**FINDINGS AND RECOMMENDATION
OFFICE OF PLANNING AND ZONING
ANNE ARUNDEL COUNTY, MARYLAND**

CASE NUMBER: 2024-0157-V

REQUEST

The applicants are requesting variances to allow a dwelling addition (deck) with less setbacks¹ and buffer than required and with disturbance to slopes of 15% or greater on property located at 6 Fetter Lane in Severna Park.

SITE DEVELOPMENT PLAN
HOLLYWOOD ON SEVERN
LOT E PLAT A
8 FETTER LANE, SEVERNA PARK, MD 21146
TAX MAP 31 BLOCK 3 PARCEL 387 TAX ACCOUNT #3440-2086-4600 ZONING: RS
DATE: FEBRUARY 11, 2025
ANNE ARUNDEL COUNTY, MARYLAND
SHEET 1 of 1

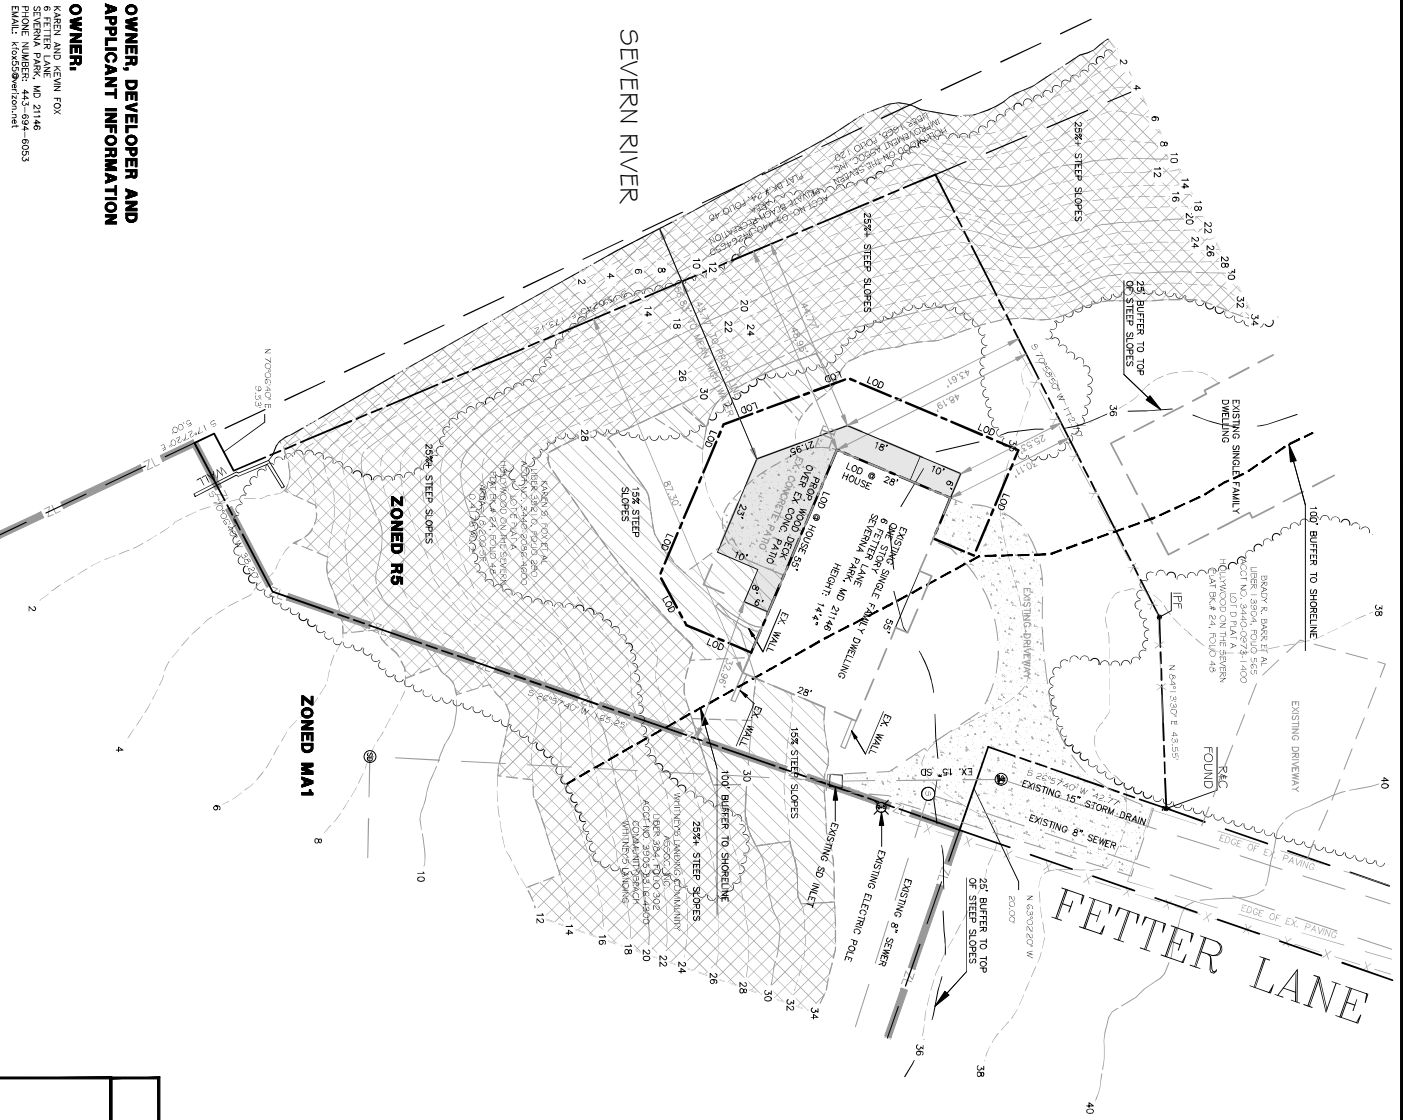
The Zoning Administration Section concurs with the Critical Area Team regarding the proposed critical area variance. Additionally, the variance site plan must show the 100-foot buffer, the steep slopes, and their associated 25-foot slope buffer. The site plan must also show the zoning line between the R5 portion of the lot and the MA 1 portion of the lot. The existing house is currently located entirely within the R5 portion of the lot, and the proposed deck must remain in the R5 portion of the lot.

Our response: The site plan has been revised to include the 100-foot buffer, the steep slopes, and their associated 25-foot slope buffer. The zoning line has been added to the site plan. The proposed deck is located entirely within the R5 portion of the lot.

The deck size has been reduced in size as requested. The variance letter has been revised as required.
